County Plan No.: S-79-98
Project Name: GOVERNORS LAND - CYPRESS ISLE
Stormwater Management Facility: DRY POND w/ SHALLOW MARSH

County Plan No. 5-79-98
 Project Name: Gov. Land - Cypress Island
 Stormwater Management Facility: JR-041

Re: Governor's Land - Cypress Isle
County Plan No. S-79-98
Dry Pond with Shallow Marsh
County BMP ID Code: JR 041

The Environmental Division has reviewed a record drawing as submitted to our office on December 28th 2001 for the above referenced BMP. The record drawing provides as-built information for a dry pond with shallow marsh facility situated northeast of the cul-de-sac at the end of Cypress Isle East.

GRADING, DRAINAGE + EROSION AND SEDIMENT CONTROL
CYPRESS ISLE
THE
GOVERNOR'S LAND
All Tree Rivers
JAMES CITY COUNTY
VIRGINIA
FOUNTAIN DISTRICT

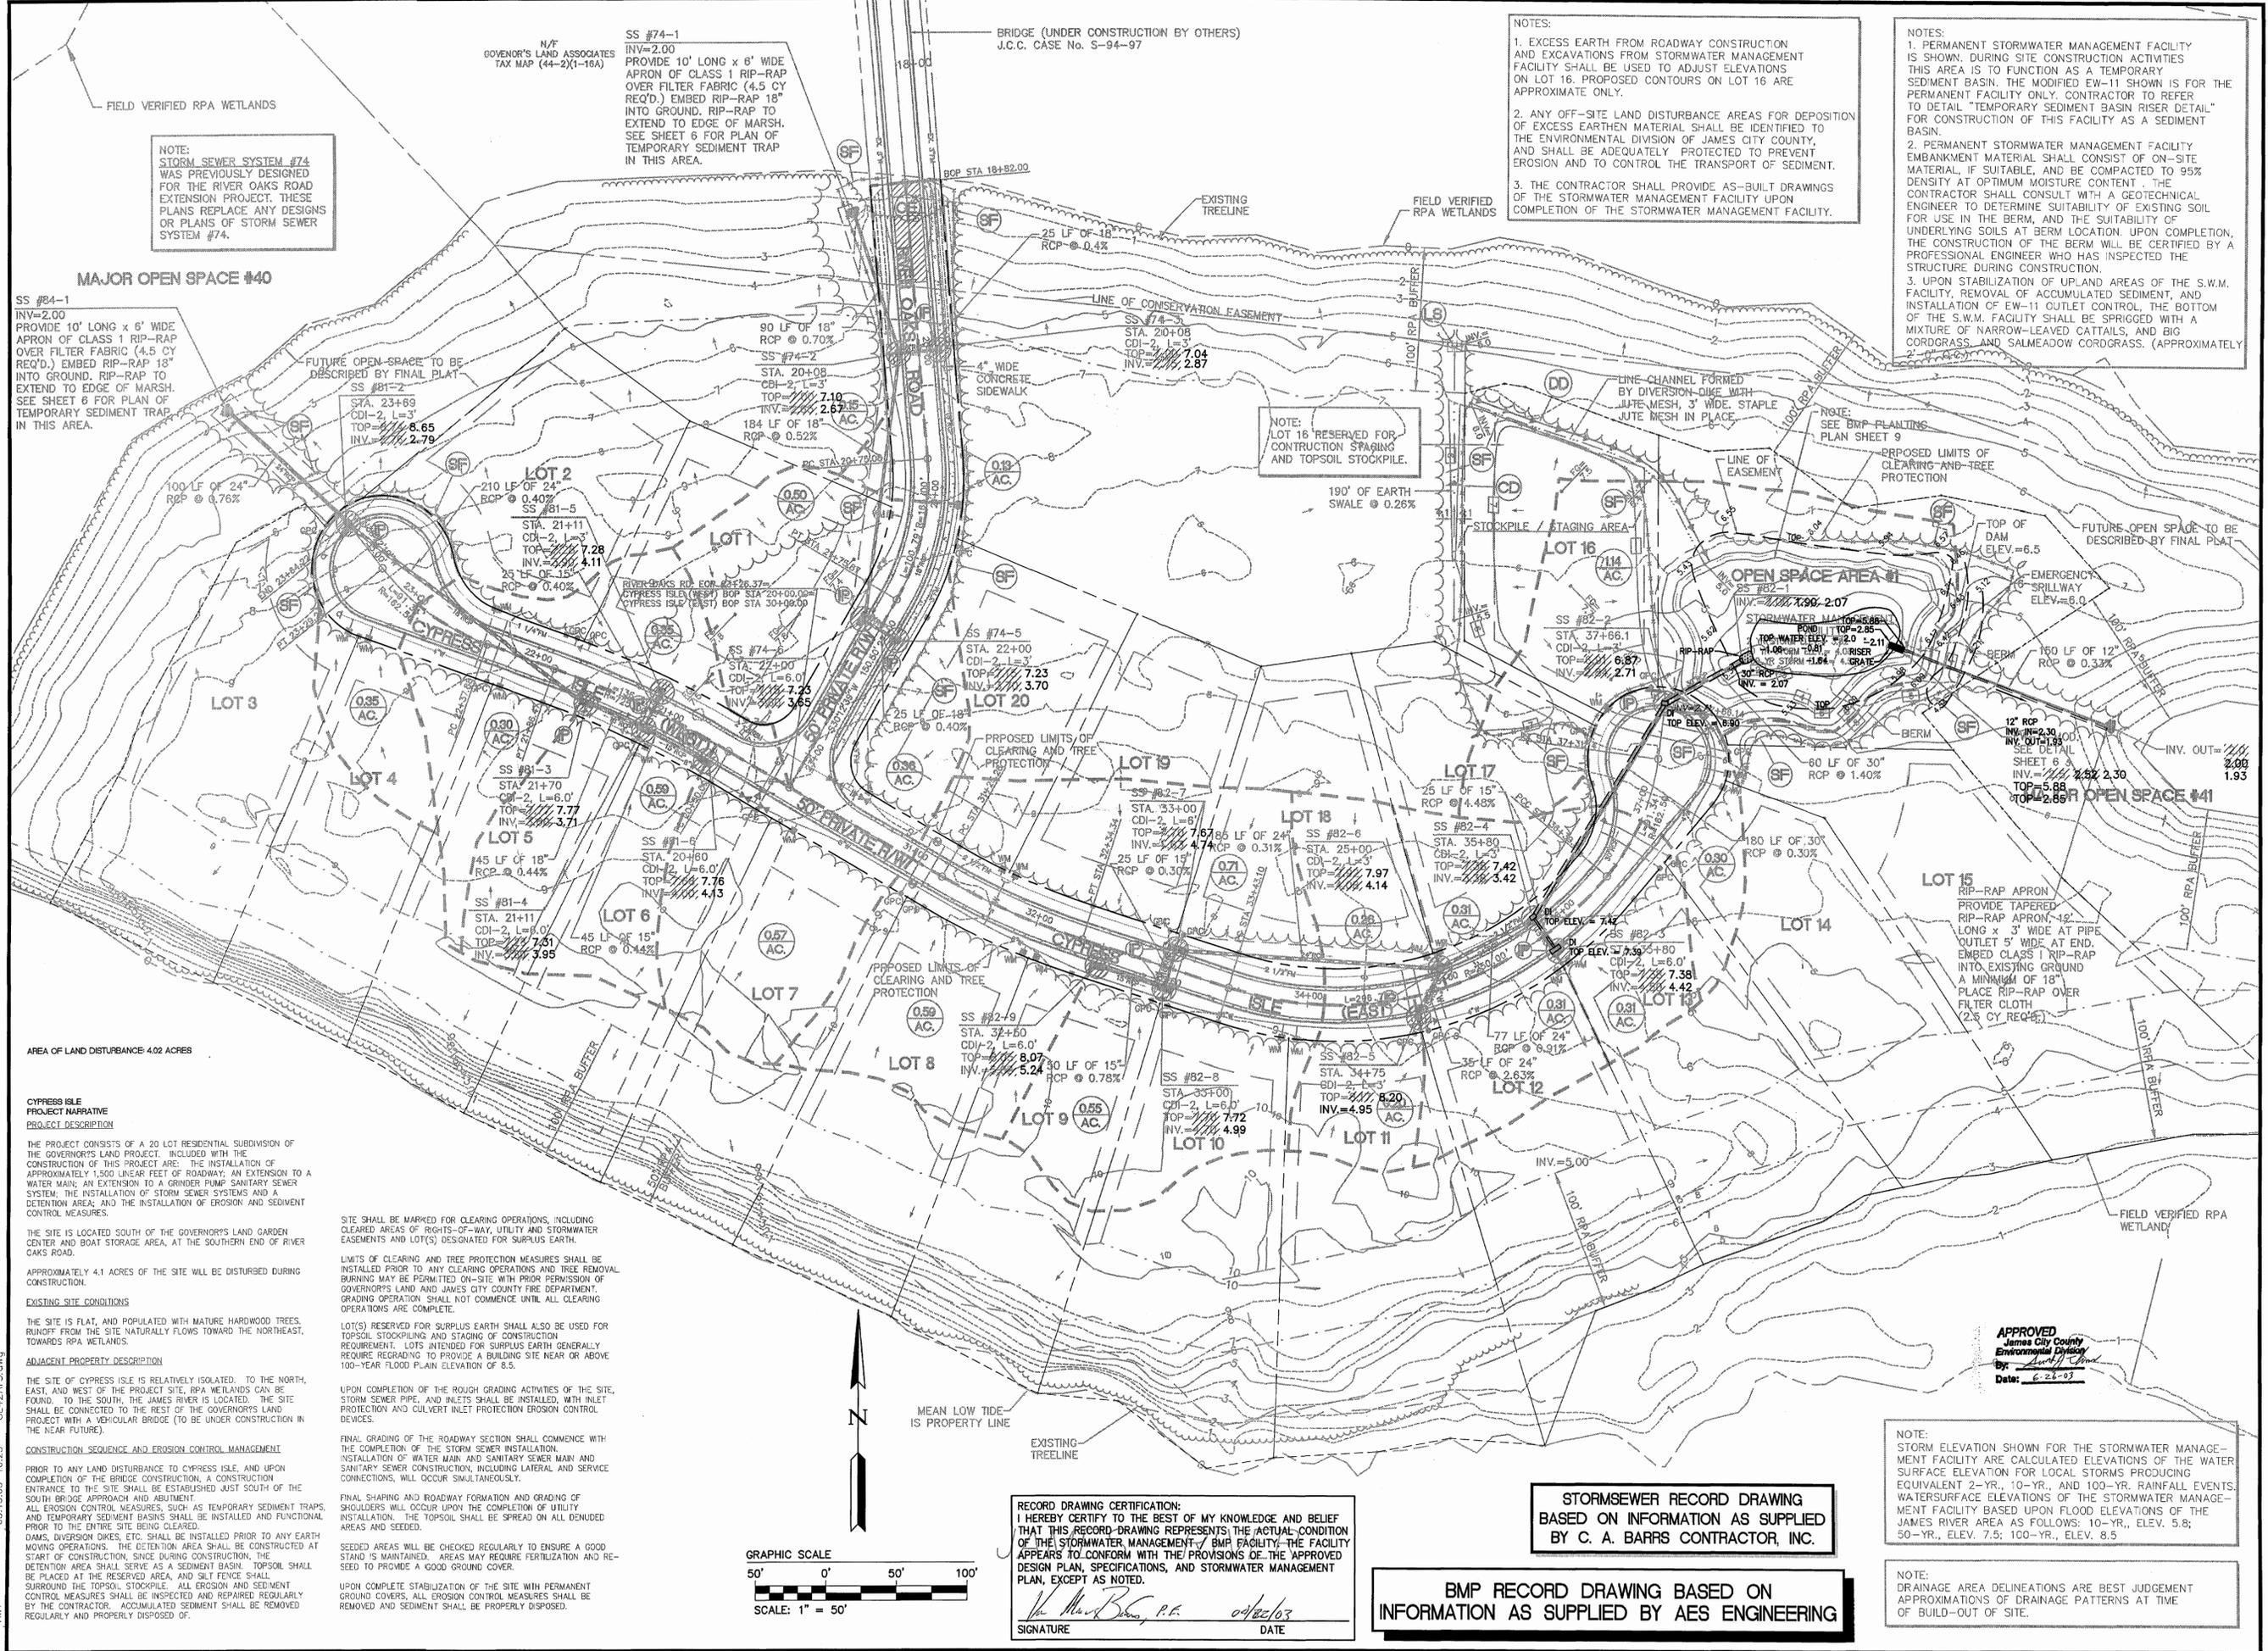
1. In accordance with the Note # 18 on Sheet 8 and Note # 3 on Sheet 5 of the approved plan, construction certification was required for the BMP. None was provided. The certification can be in letter format or by use of the certification statements in Section 4 of the *James City County, Stormwater Management / BMP Facilities, Record Drawing and Construction Certification, Standard Forms & Instructions.*

2. The professional certification on Sheet 1 (Sheet 5) of the record drawing is blank and requires signature and date.

3. Based on the approved design and constructed top of dam information, approximately 1.57 ft. of freeboard exists from design high water to the low top of dam spot elevation (El. 6.09). However, the outfall end of the 12-inch barrel through the dam was not constructed in accordance with the approved plan. The approved plan called for the outlet end of the 12-inch barrel to daylight to existing ground (at El. 2.0) and have a standard Class I riprap outlet protection pad. Based on asbuilt elevations and field observation, the outfall invert was

constructed well below existing ground elevation in a sump type condition. Provide routing computations using asbuilt elevations to show a submerged barrel outfall condition as such will not increase the 100-year design high water surface elevation to a point where freeboard is reduced to less than 1 ft. or the dam is overtopped at Elevation 6.08.

REVISIONS AS PER JAMES CITY COUNTY REVIEW	VMB
RECORD DRAWING (ADDITIONAL)	VMB
RECORD DRAWING	VMB
RECORD DRAWING	VMB
REVISION / COMMENT / NOTE	BY
5/17/03	
10/28/01	
12/27/00	
6/00	
11/10/99	
NO. DATE

RECORD DRAWING CERTIFICATION:
I HEREBY CERTIFY TO THE BEST OF MY KNOWLEDGE AND BELIEF THAT THIS RECORD-DRAWING REPRESENTS THE ACTUAL-CONDITION OF THE STORMWATER MANAGEMENT / BMP FACILITY. THE FACILITY APPEARS TO CONFORM WITH THE PROVISIONS OF THE APPROVED DESIGN PLAN, SPECIFICATIONS, AND STORMWATER MANAGEMENT PLAN, EXCEPT AS NOTED.
Vanessa Barrs, P.E.
SIGNATURE DATE 04/22/03
